**98. Final Simulation Verification of the US and Opto Receiver Band Pass Amplifiers  
for the US-Opto Receiver designed by F. Kottelat**

**DRAFT 1.0**

PAN, Nov 7th, 2015

Fig. 1: Circuit US Band Pass 40 kHz

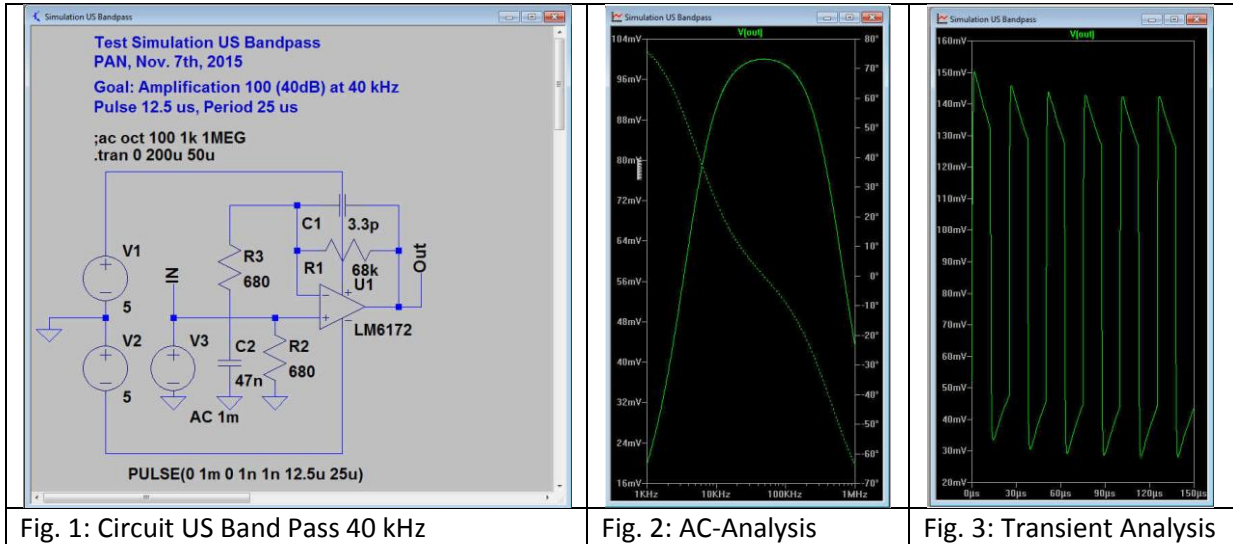
Comment: Perfect Performance, Gain 100 (40dB), Offset 100 mV, but ok for AC-Coupling to the next stage

Fig. 5: Circuit Opto Band Pass 15.6 kHz

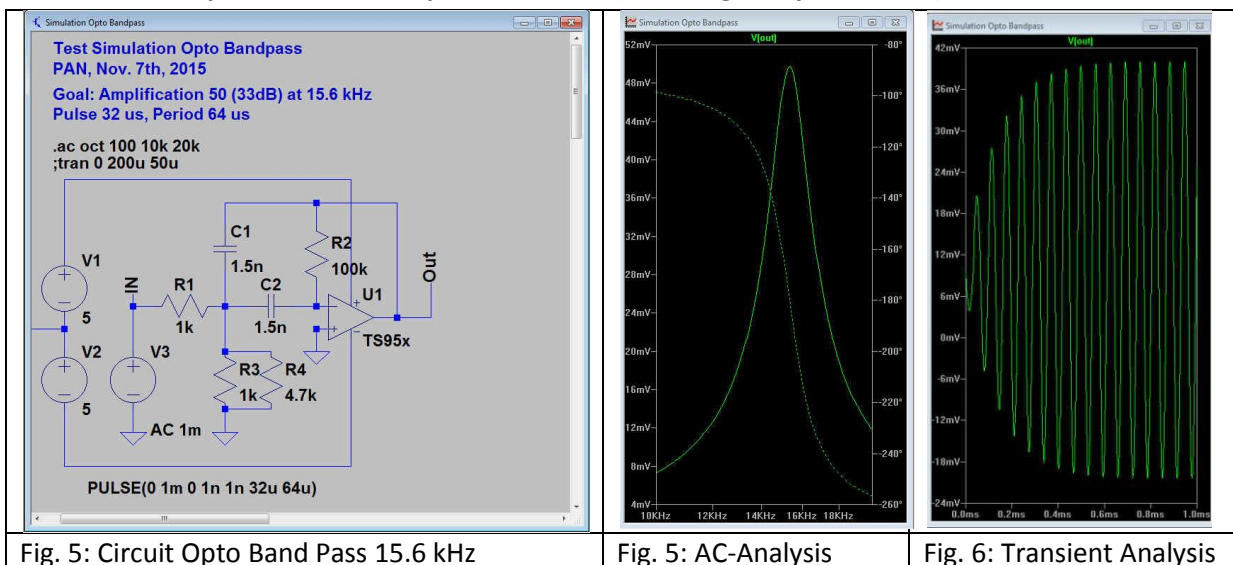
Comment: Quite good performance, Gain 50 (33dB), Offset only 12 mV, ok for AC-Coupling to the next stage. High Q, about factor of 10, good for suppressing wrong optical signals.  
Perhaps not perfect: slow reaction on incoming 15.6 kHz burst, due to the high Q factor!  
If needed, better results could be achieved perhaps with the more expensive high speed Opamp LM6172 (much more supply current!), in a circuit as shown in Fig. 1 for the US-Band pass amplifier!
